# PRELIMINARY PLAN MEADOW LAKE INDUSTRIAL FILING NO. 1

A PART OF THE EAST HALF OF SECTION 9, TOWNSHIP 13 SOUTH, RANGE 64 WEST OF THE SIXTH PRINCIPAL MERIDIAN, COUNTY OF EL PASO, STATE OF COLORADO

# V1\_Preliminary Plan Drawings.pdf Markup Summary 10-24-2023

VICINITY MAP  
(NOT TO SCALE)

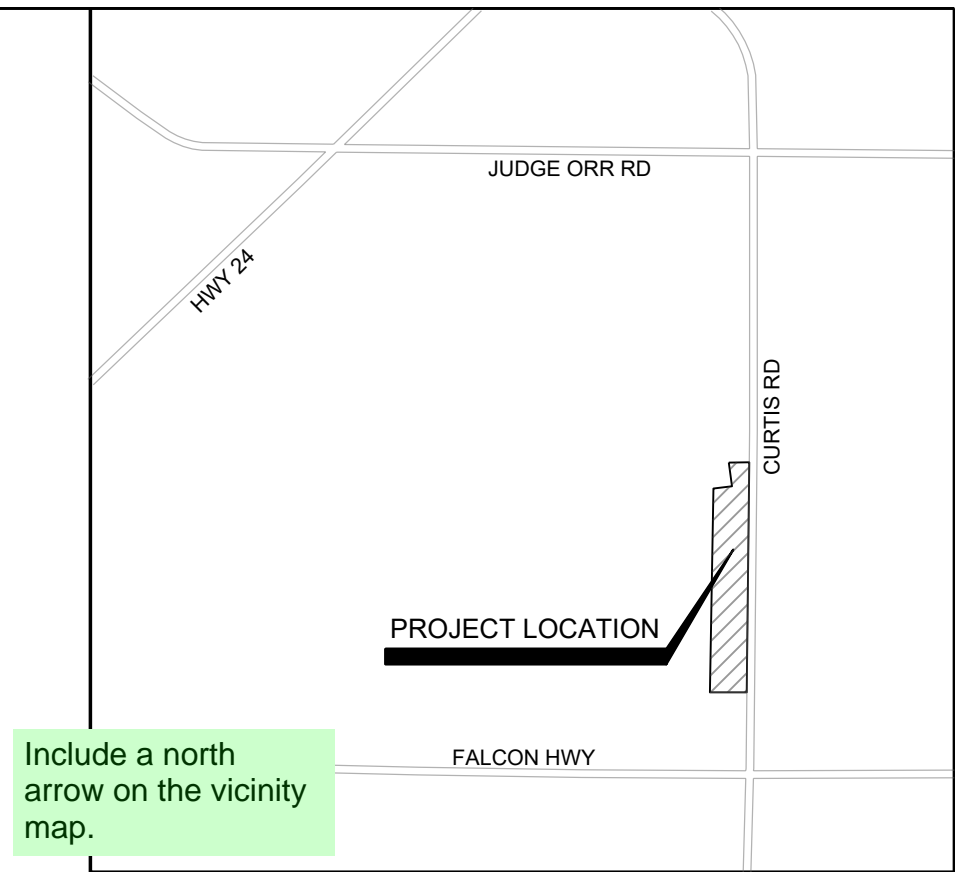
Include a north arrow on the vicinity map.

# PRELIMINARY OVERALL SITE PLAN MEADOW LAKE INDUSTRIAL FILING NO. 1

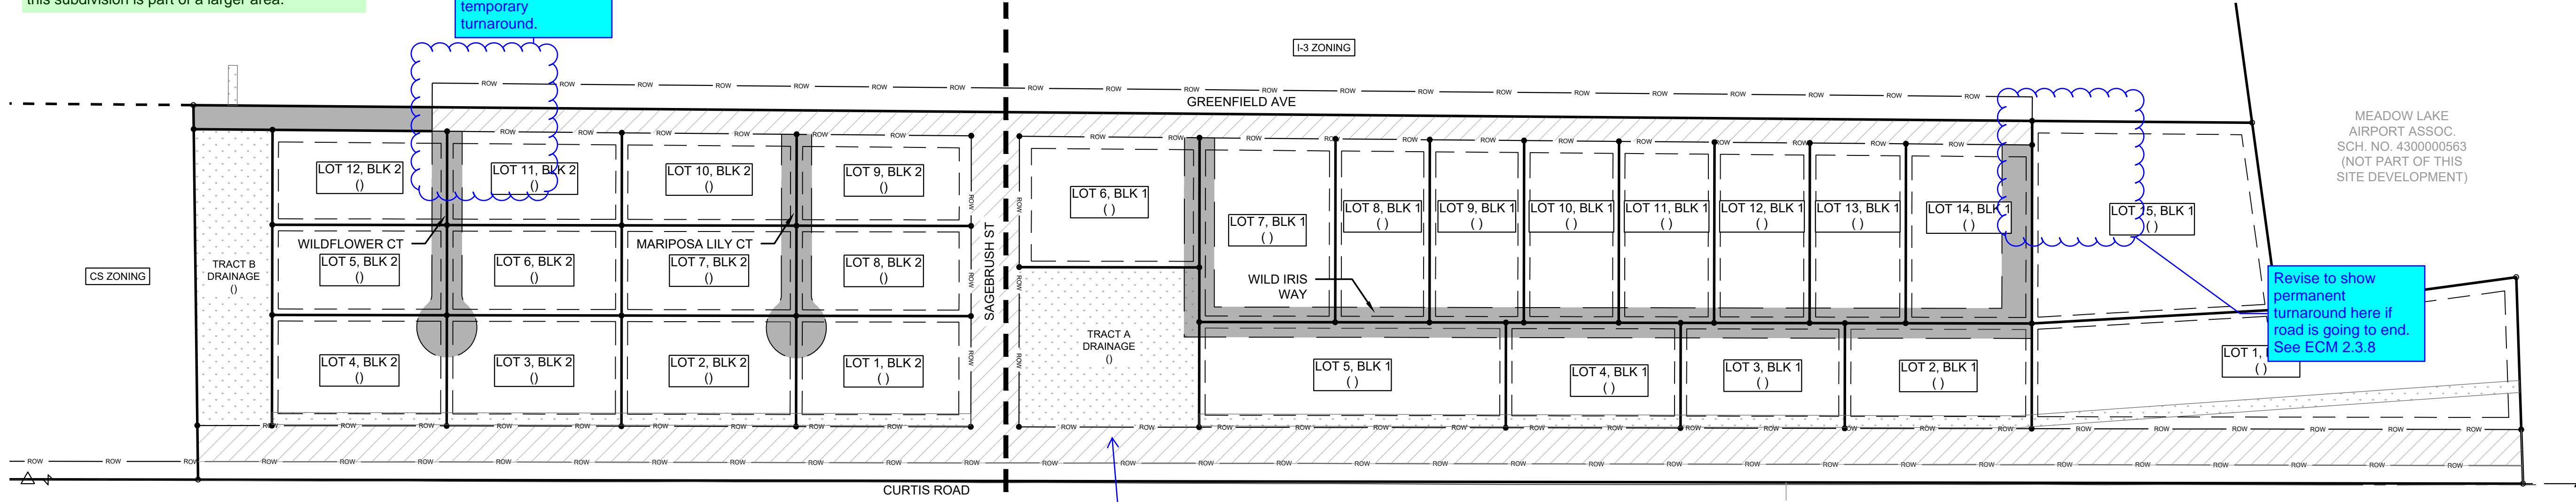
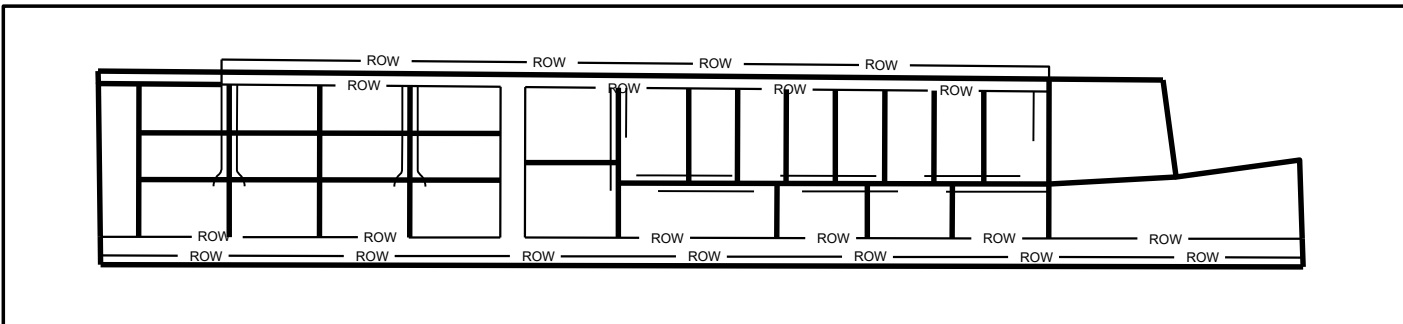
Include the location of property lines including location and boundaries of the subdivision since this subdivision is part of a larger area.

Revise to show permanent turnaround here if road is going to end. See ECM 2.3.8. If road will be extended in the future, provide temporary turnaround.

Revise to show permanent turnaround here if road is going to end. See ECM 2.3.8.

These notes should say "not a part of this subdivision"

Revise to show 72' of ROW dedication from centerline of Curtis Road that will be required for this development. The dedication should be along the entire frontage of the development.

Please also show and label the ROW preservation (18'). This will match what was determined with the Saddlehorn Subdivision to the north.

It is preferred that the acreages and square footages be displayed within the lots on pages 3-4, instead of in the table. This is more of a request than a requirement, but would help to clean up the plan and improve clarity. Please remove the block designation and label the lots as 1-27.

# PRELIMINARY ENLARGED SITE PLAN MEADOW LAKE INDUSTRIAL FILING NO. 1

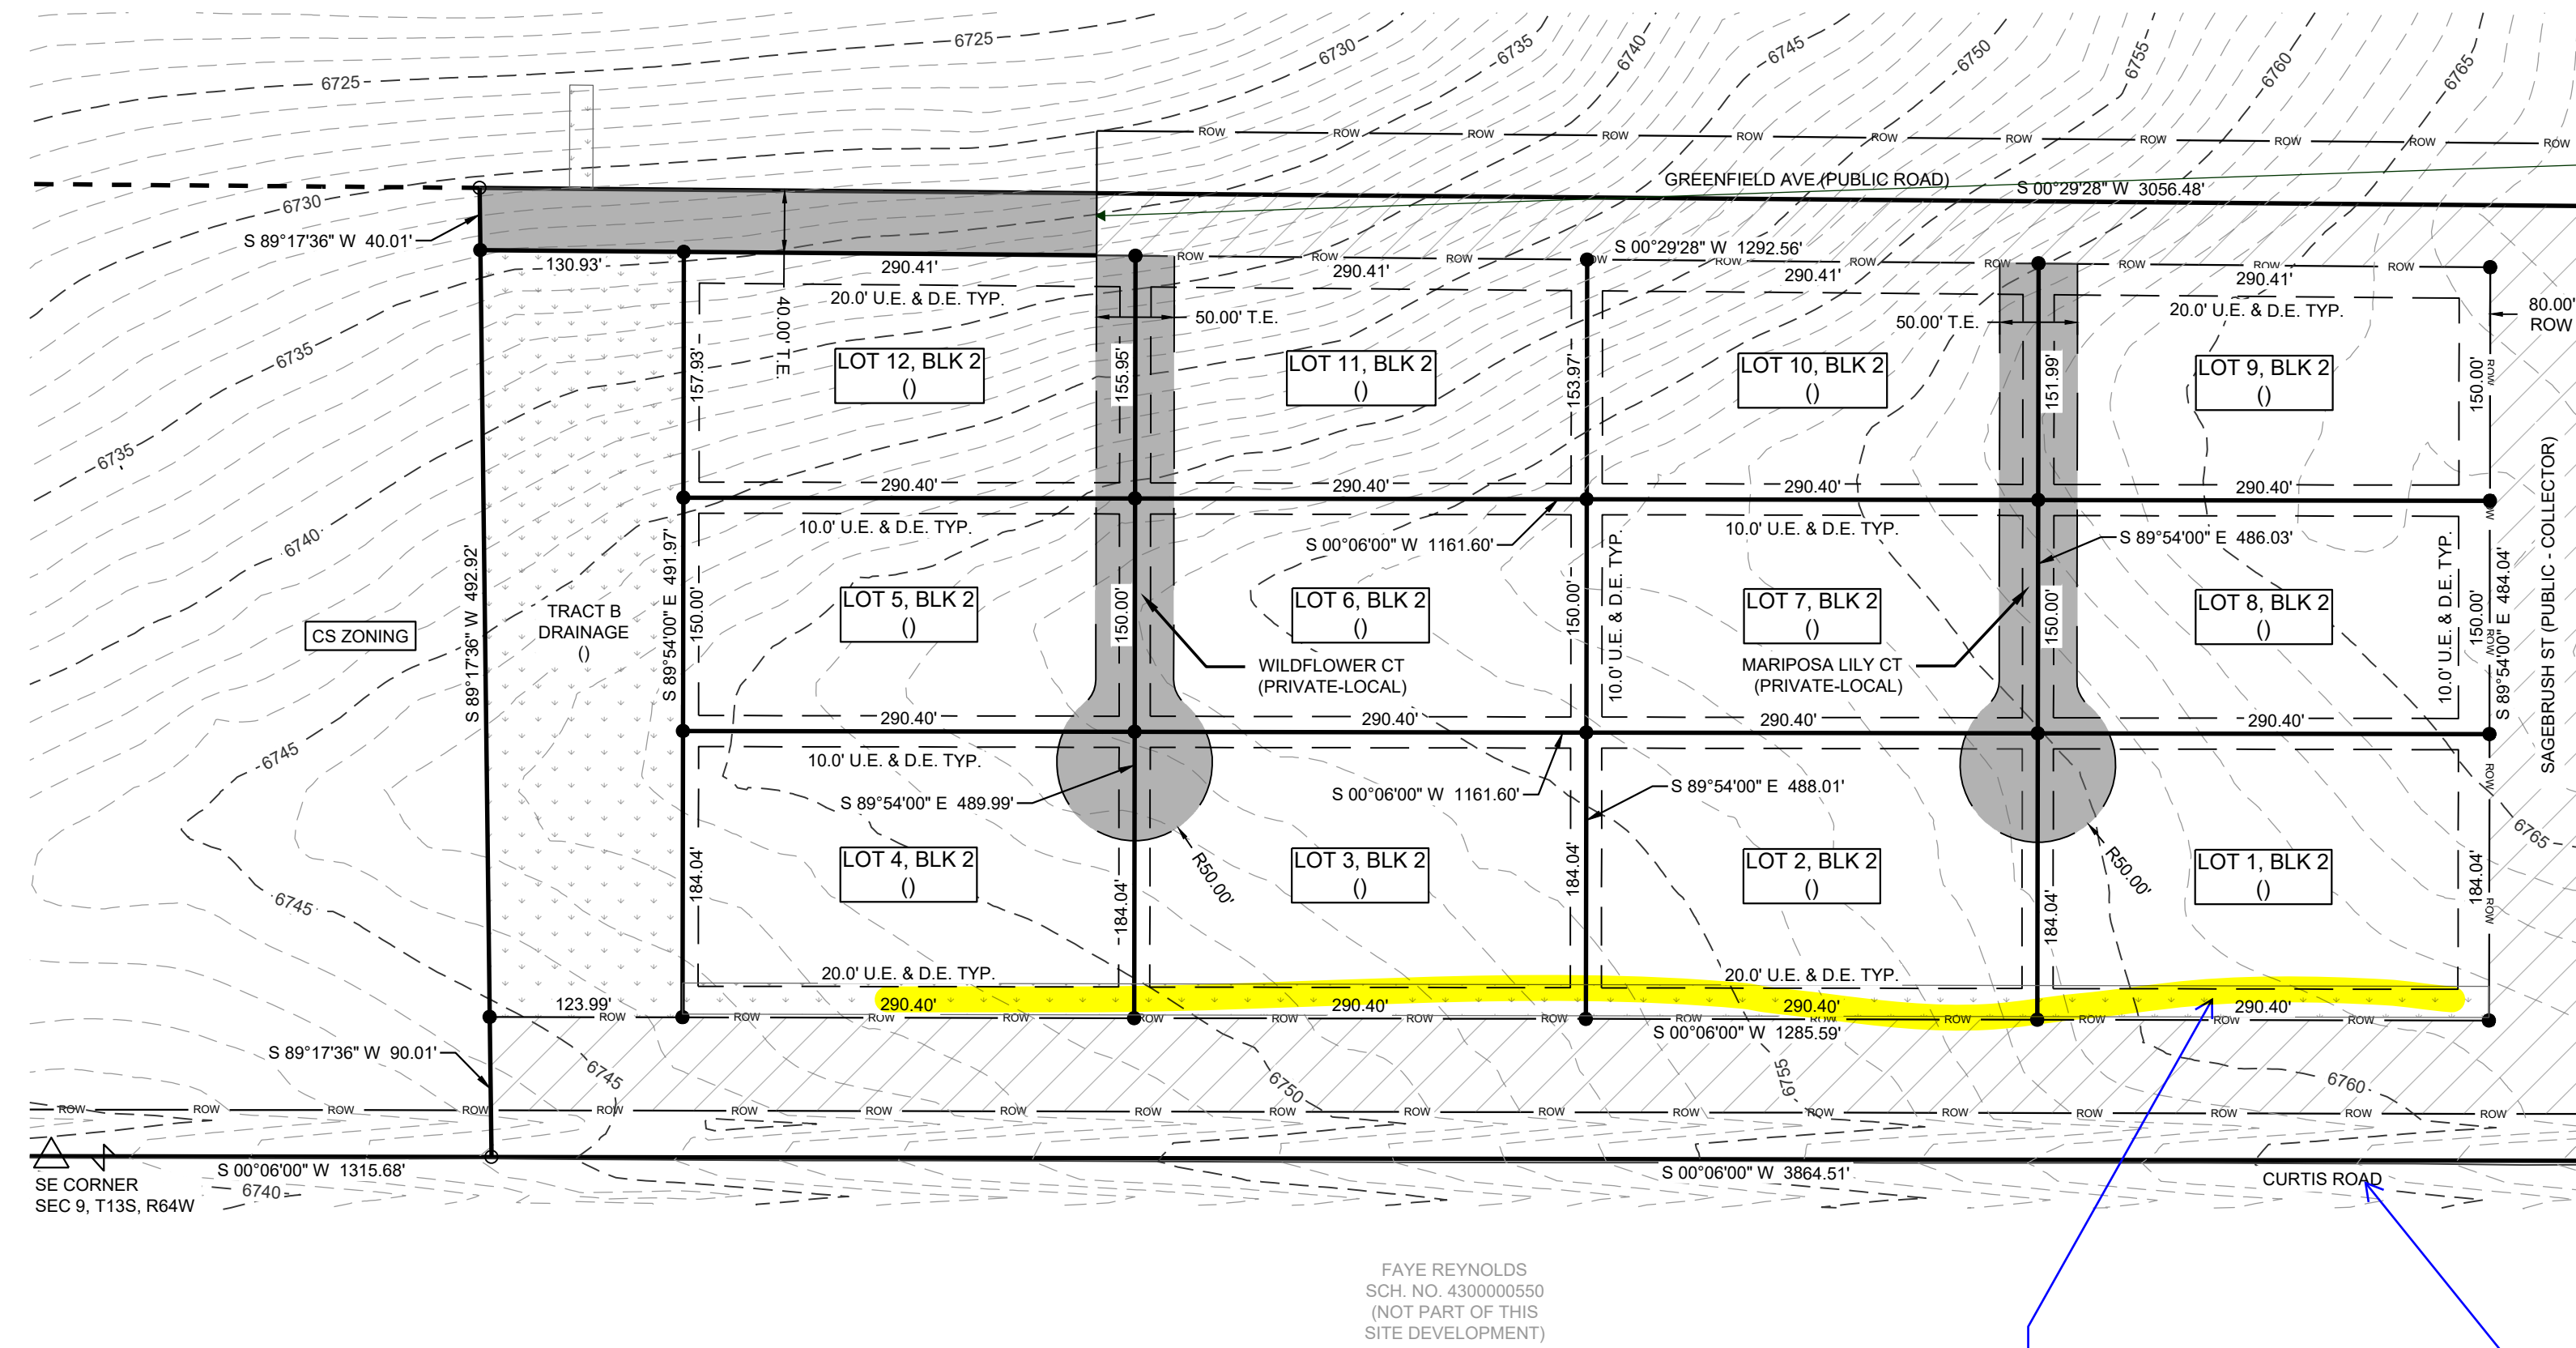
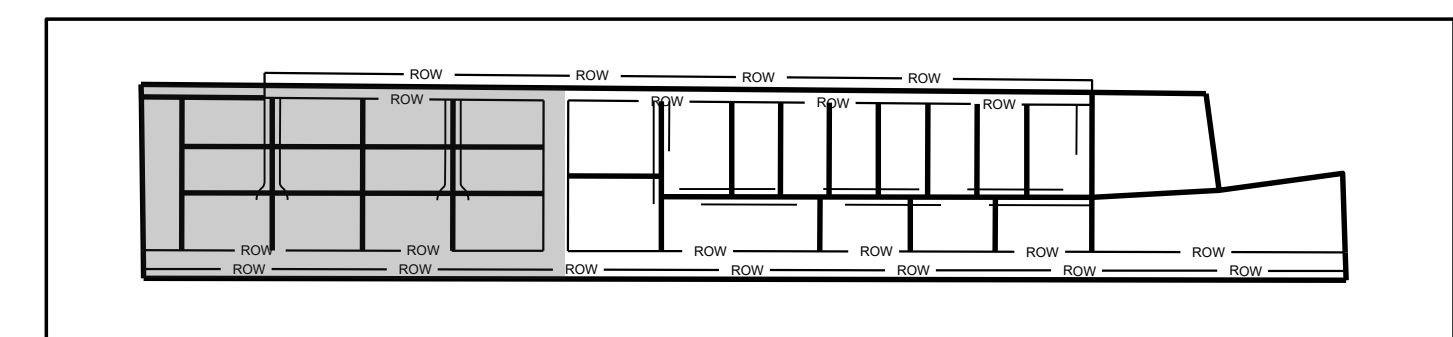
Why is only half of Greenfield Ave hatched as ROW? It looks like it dead ends into a private portion to the south.

coordinate with the drainage engineer regarding the width of the drainage easement at rear of these lots and update as needed.

The TIS identifies turn lane improvements at Curtis and Sagebrush. Please include these in the preliminary plan as well as any other improvements that are required/recommended by the traffic engineer.

# PRELIMINARY ENLARGED SITE PLAN MEADOW LAKE INDUSTRIAL FILING NO. 1

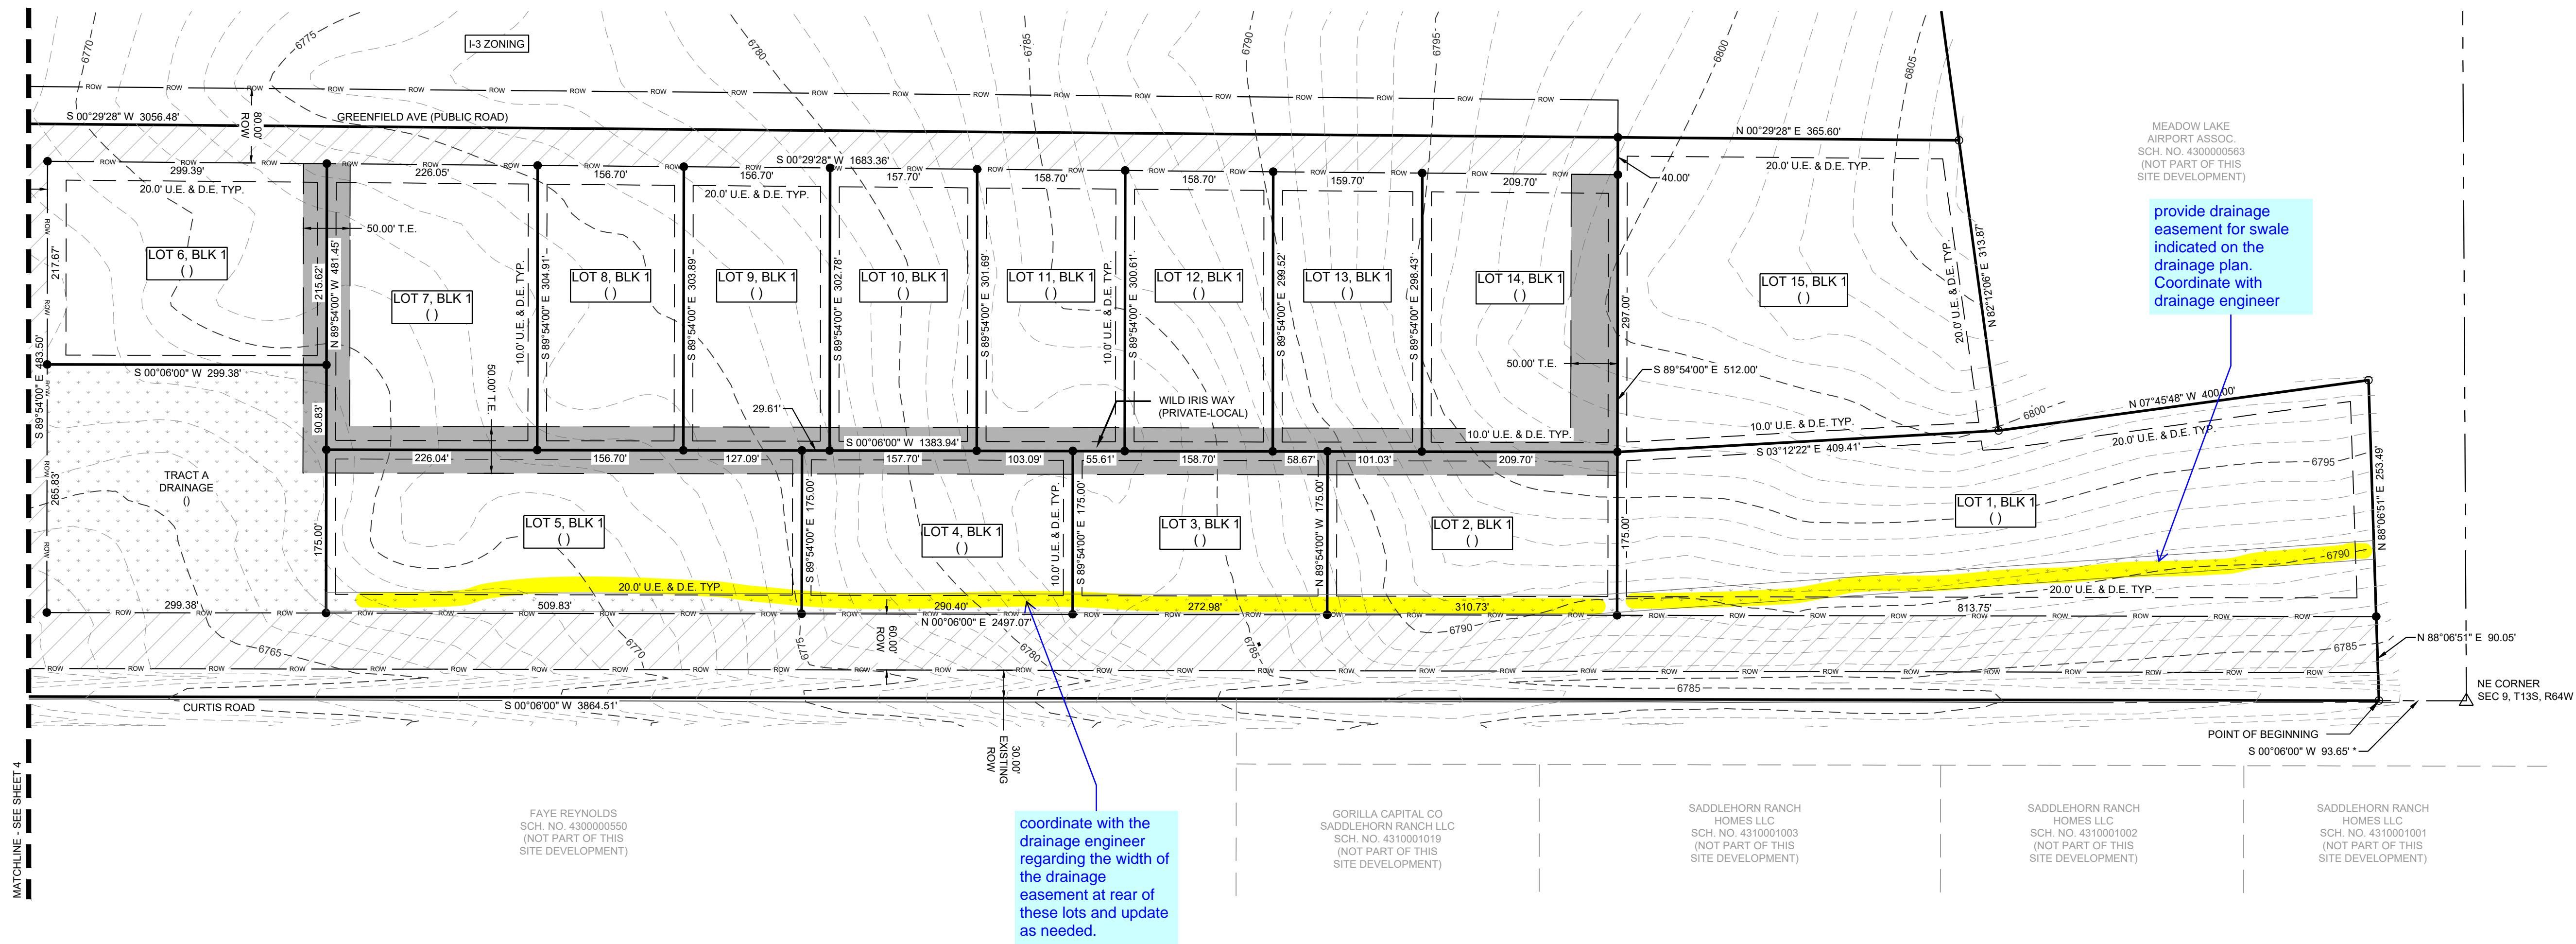
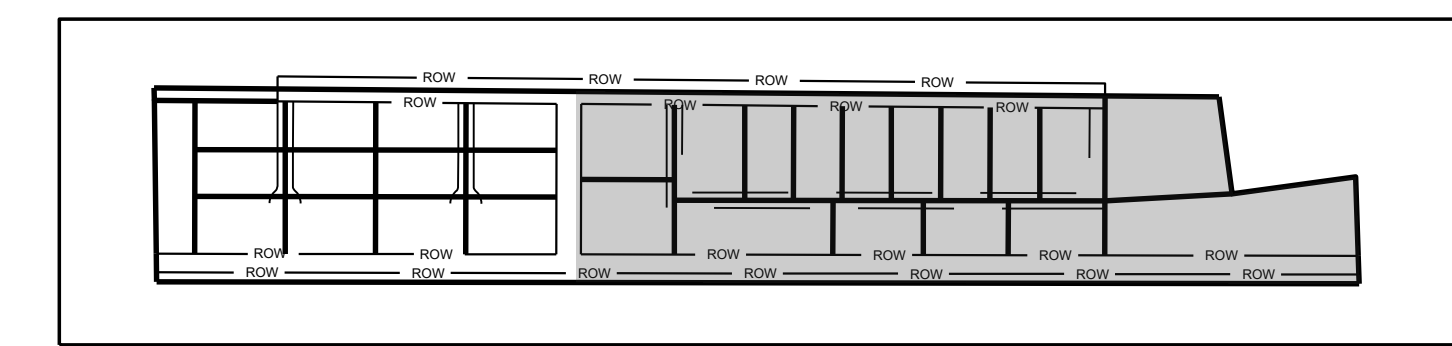
provide drainage easement for swale indicated on the drainage plan. Coordinate with drainage engineer

coordinate with the drainage engineer regarding the width of the drainage easement at rear of these lots and update as needed.
